**Proposed Temporary Warehouse (Excluding Dangerous Goods Godown) with Ancillary Facilities
and Associated Filling of Land for a Period of 3 Years in "Agriculture" Zone,
Various Lots in D.D. 107, Fung Kat Heung, Kam Tin North, Yuen Long, New Territories**

(S.16 Planning Application No. A/YL-KTN/1266)

Responses-to-Comments

(Application No. A/YL-KTN/1266)

Fig.1

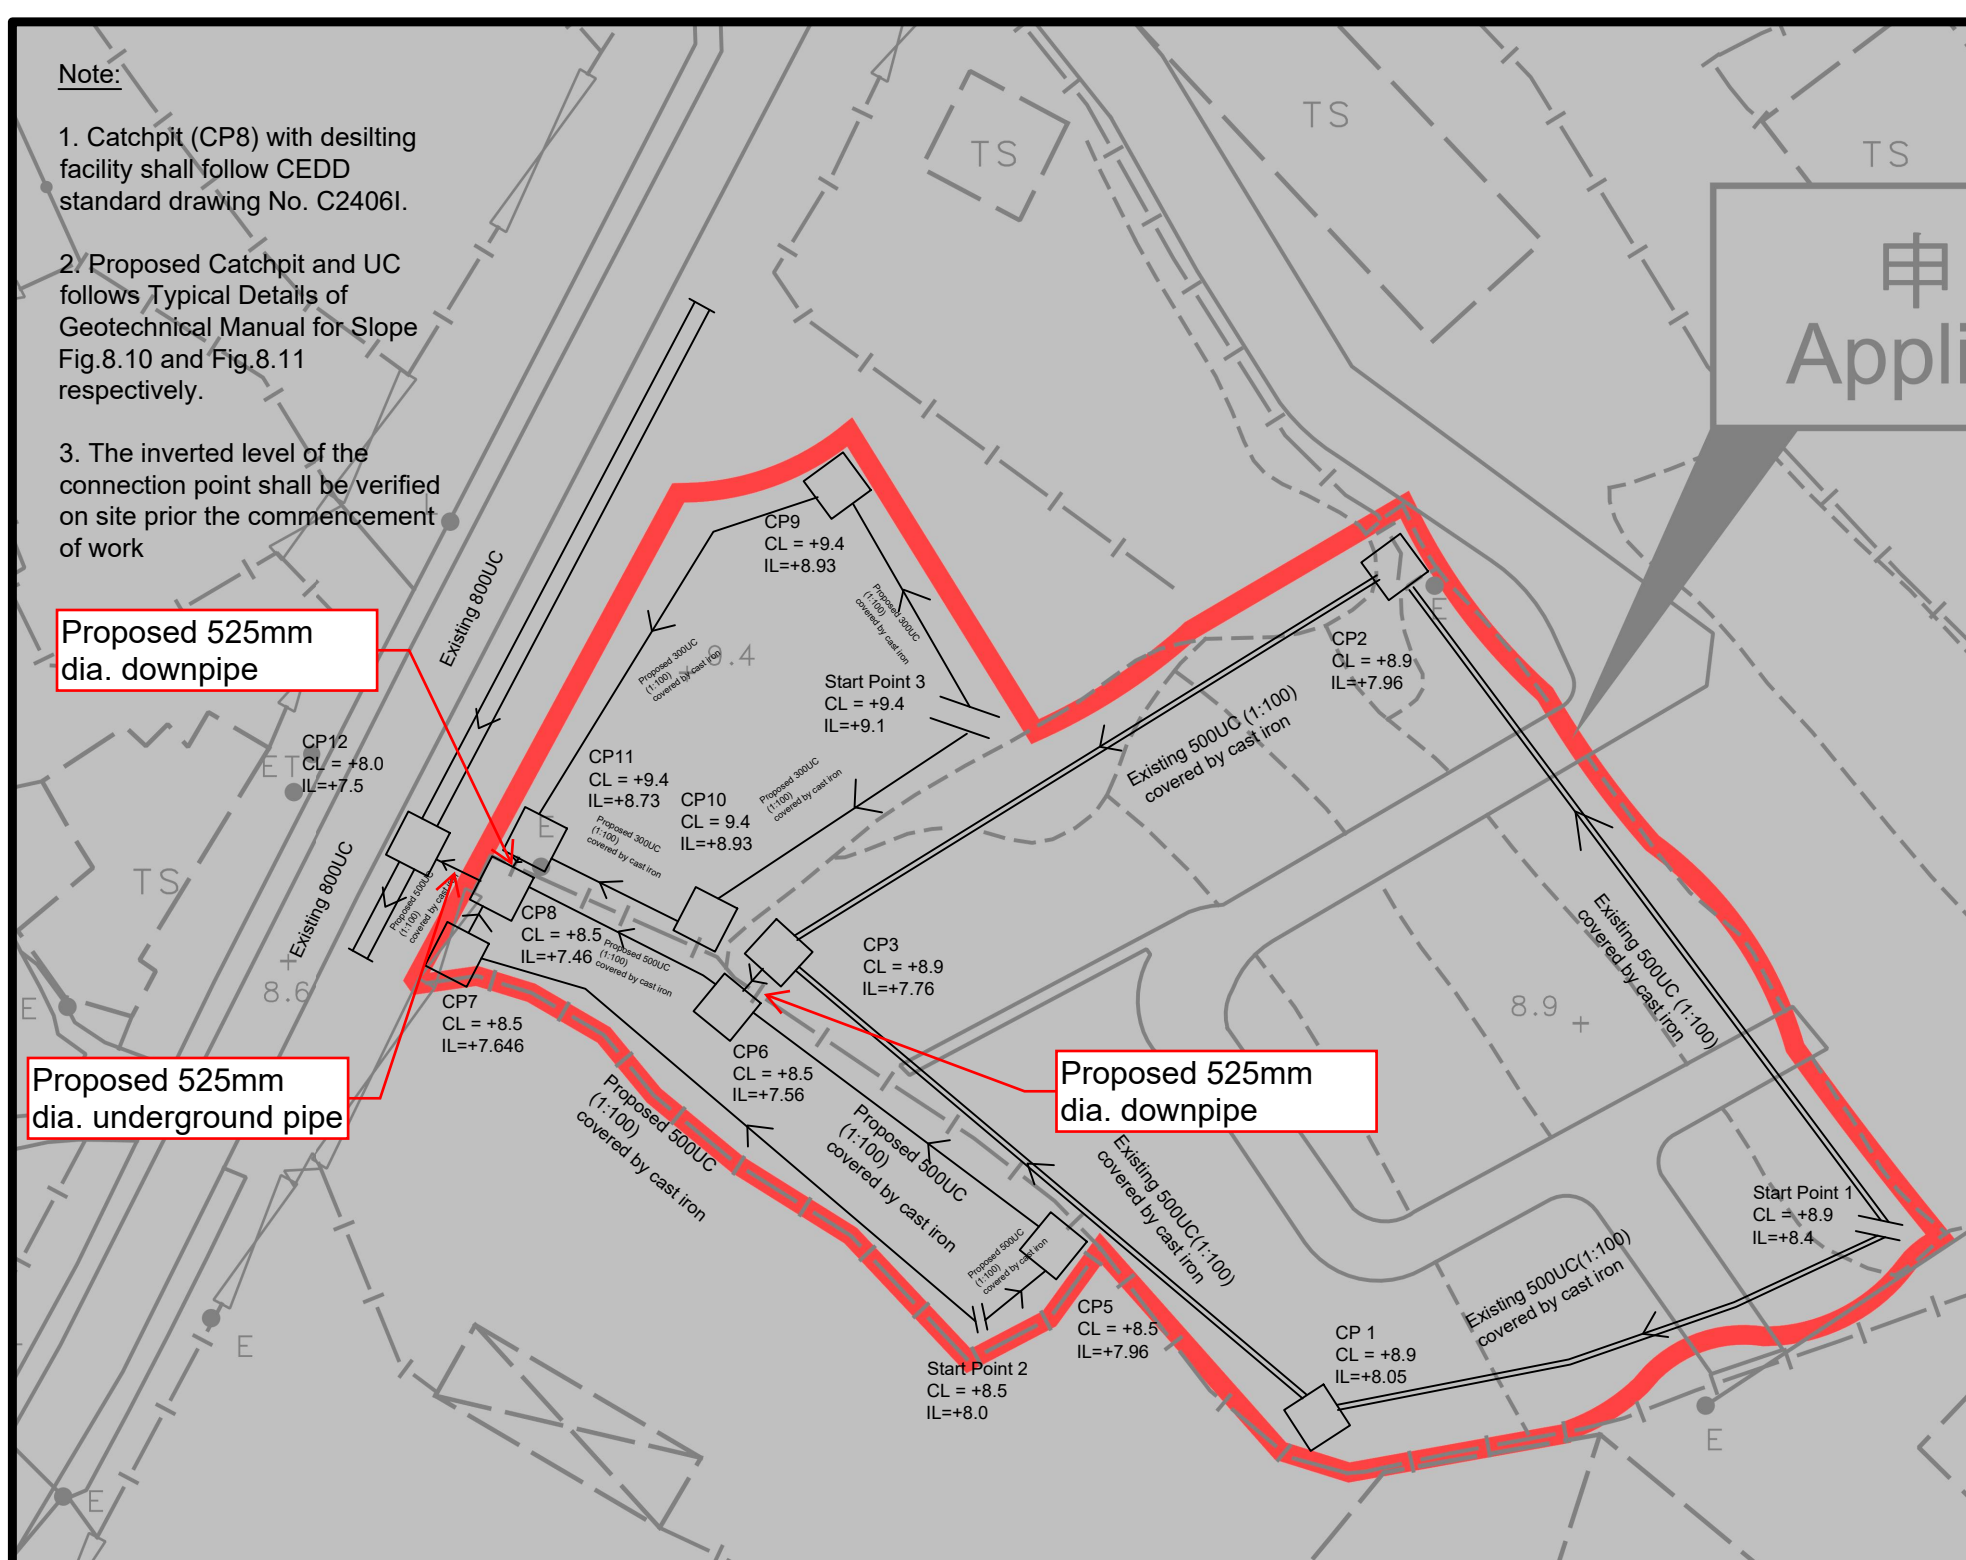
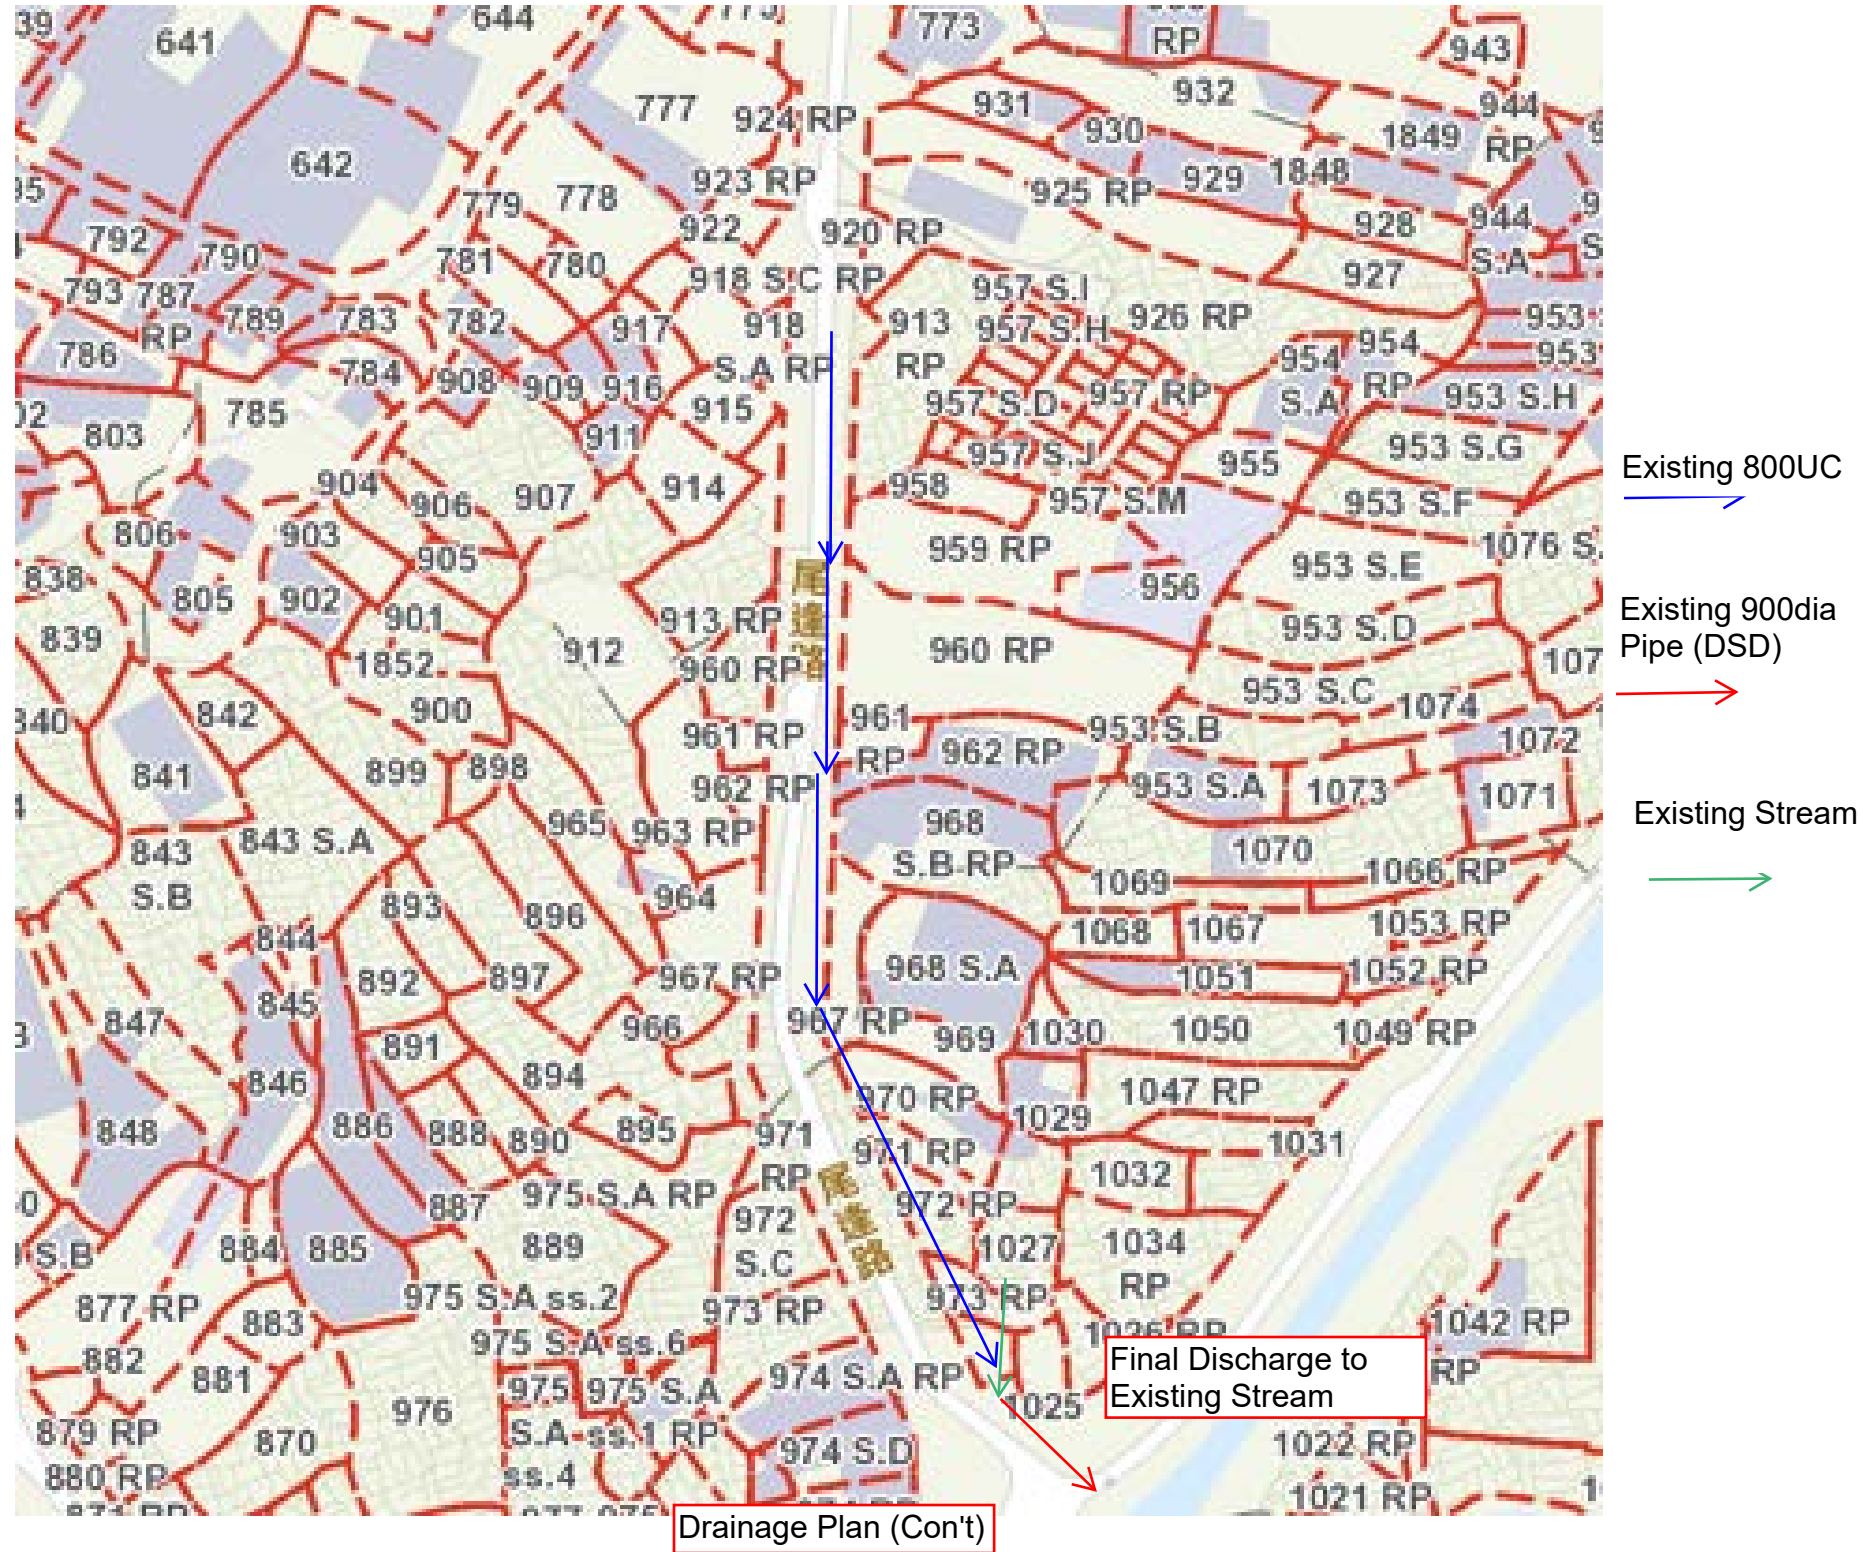
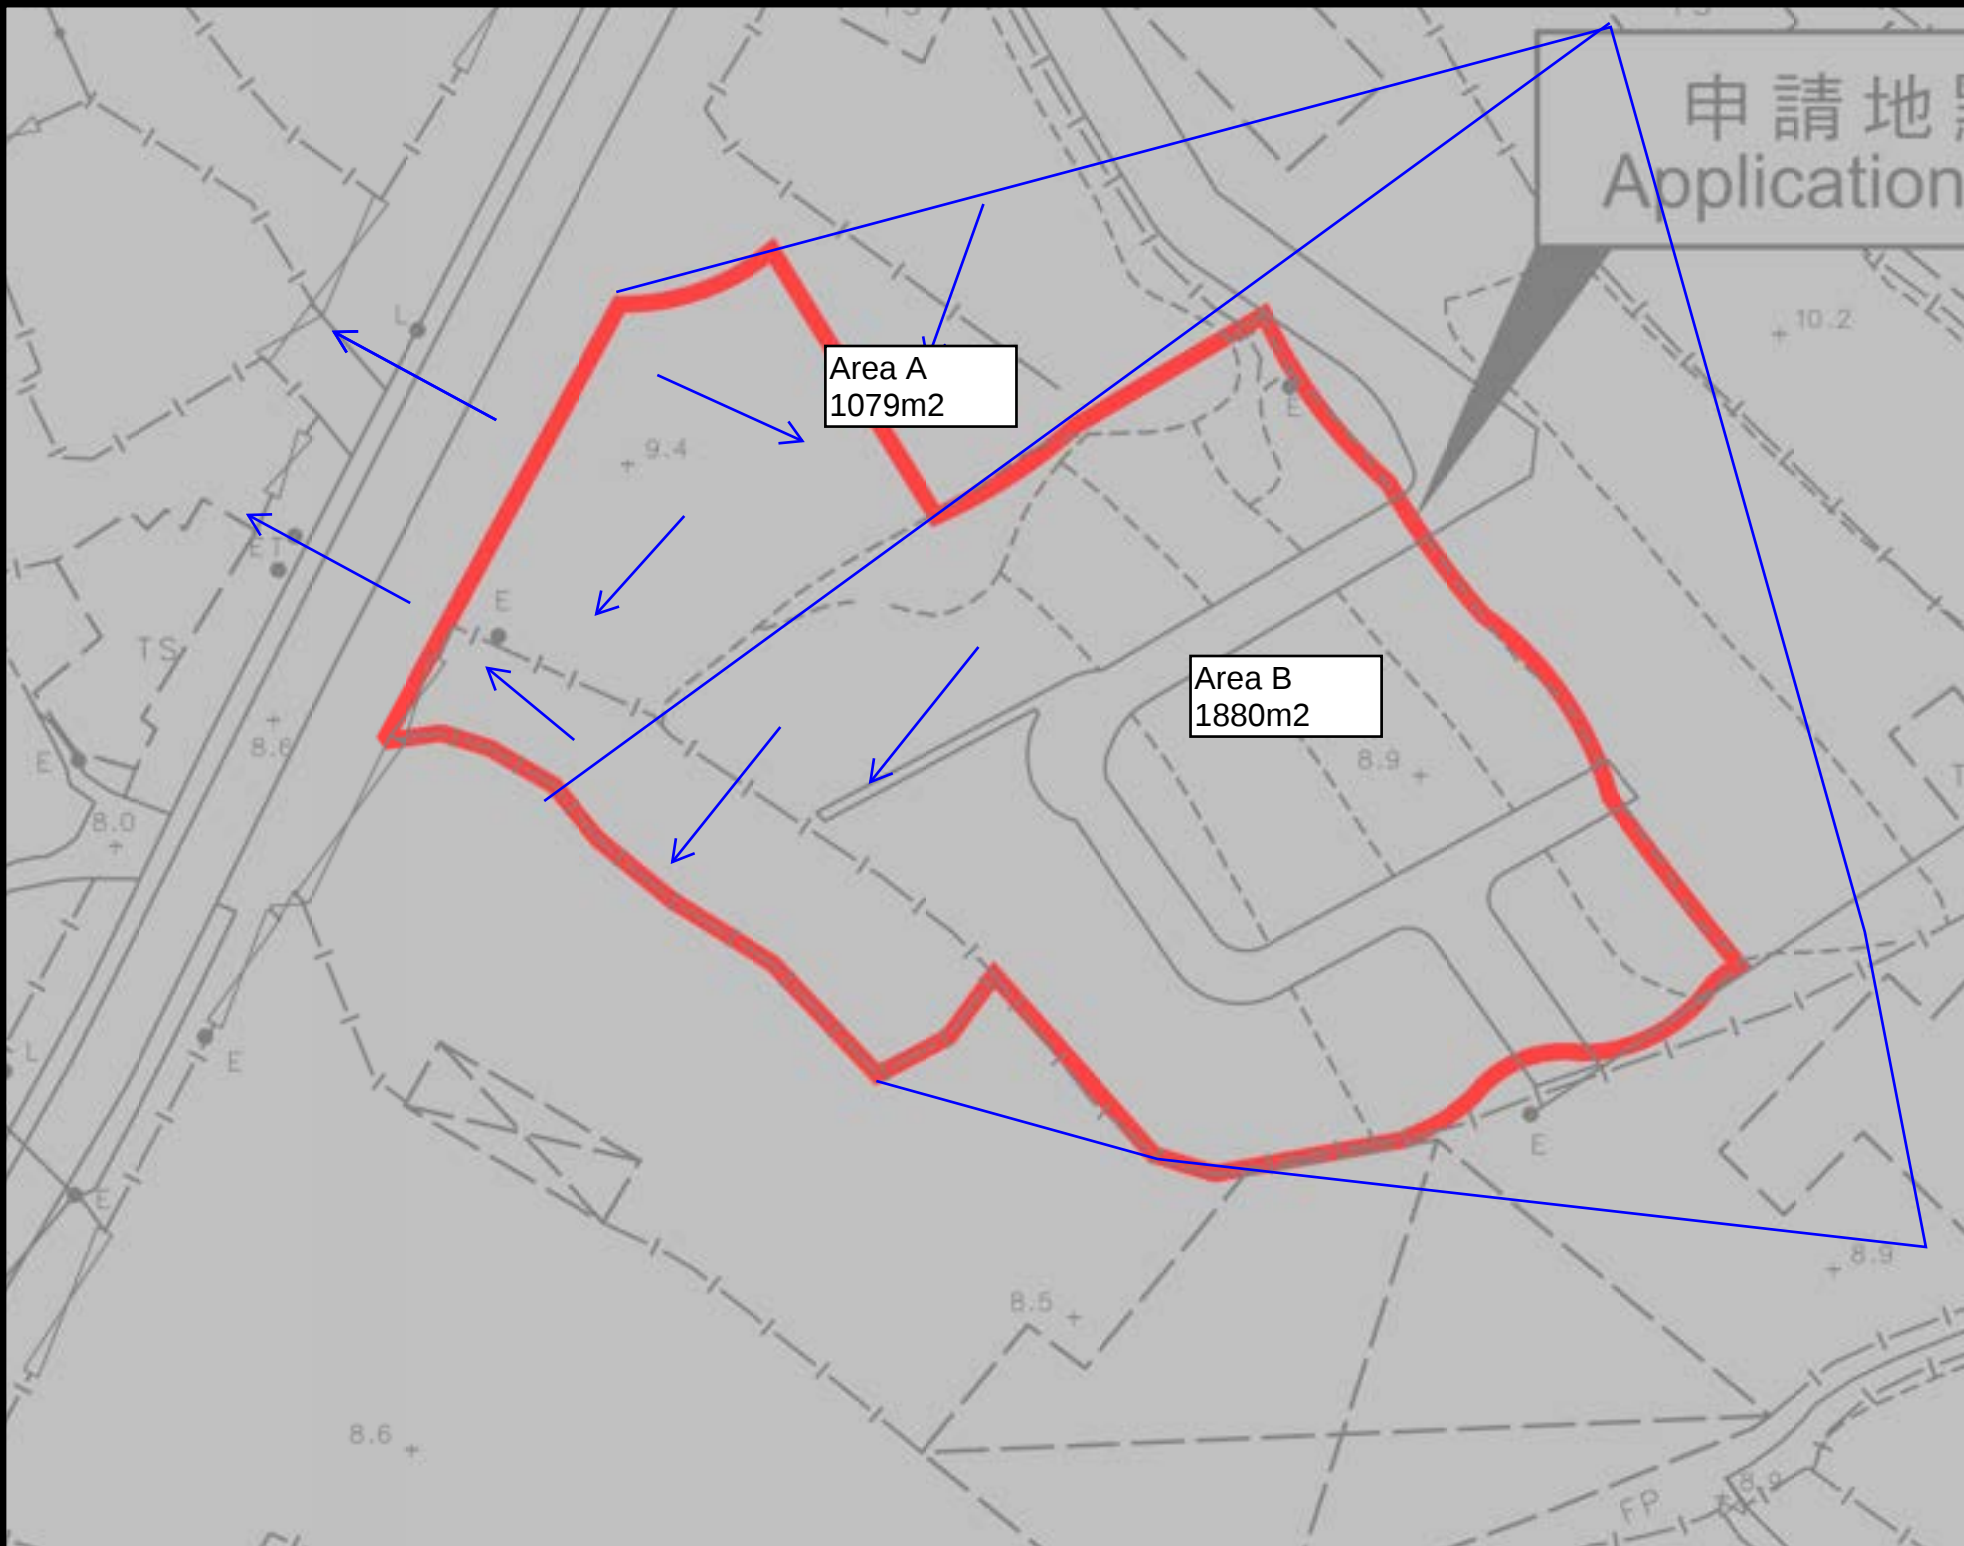
(2)	The applicant should clarify name, cover level and invert level of existing catchpit at the downstream of the proposed catchpit CP8. Invert levels of drainage facilities at the upstream should be higher than that at the downstream.	The catchpit at downstream stream of CP8 has been renamed as CP12 (Appendix II).

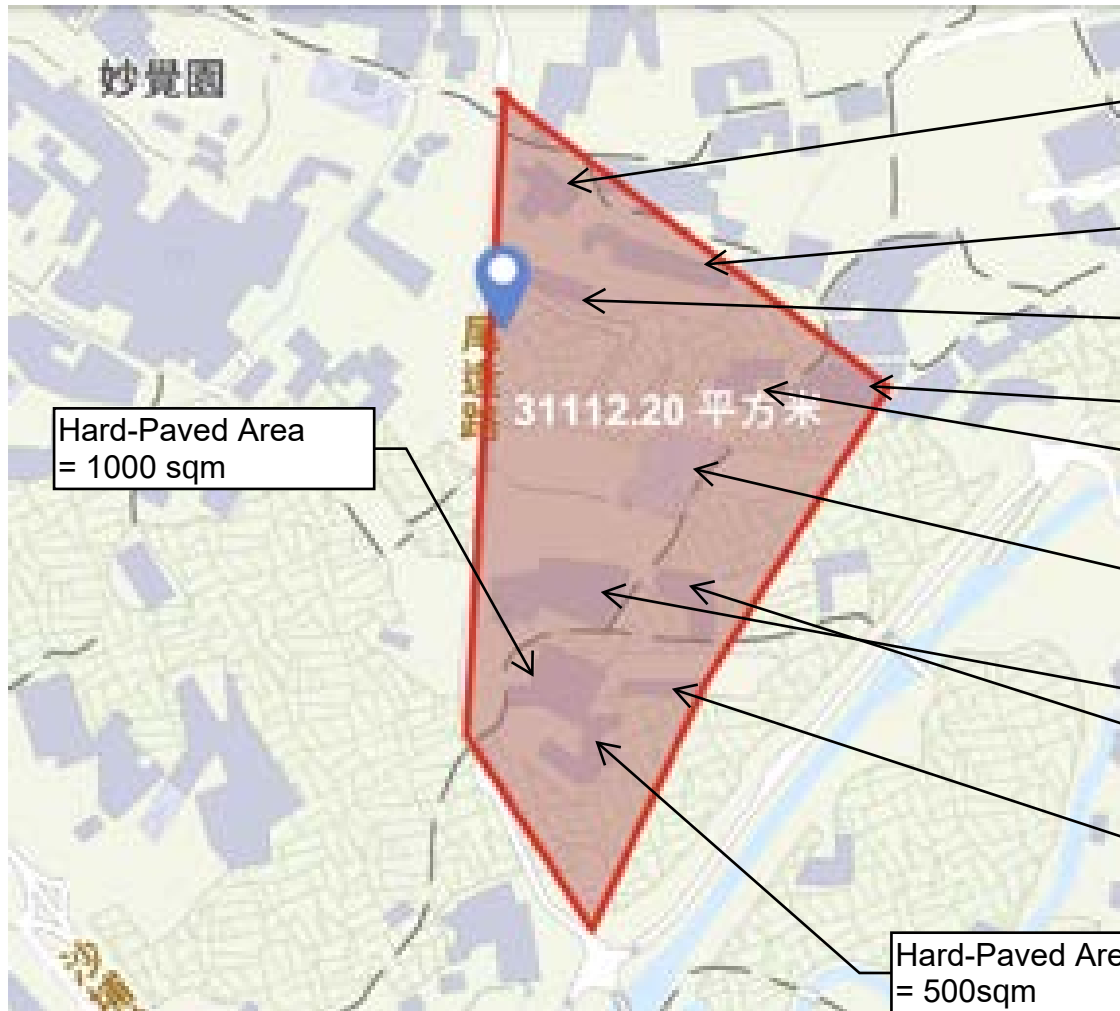
(4)	The applicant should clarify discrepancy of design rainfall intensity shown in the submitted hydraulic calculation .	The design rainfall intensity calculation has been reviewed and corrected as 266mm/hr.

$$i = \frac{(505.5)}{(6+3.29)^{0.355}} (1+16\%) = 229 \times (1+16\%) = 266 \text{ mm/hr}$$

i = 266 mm/hr is taken
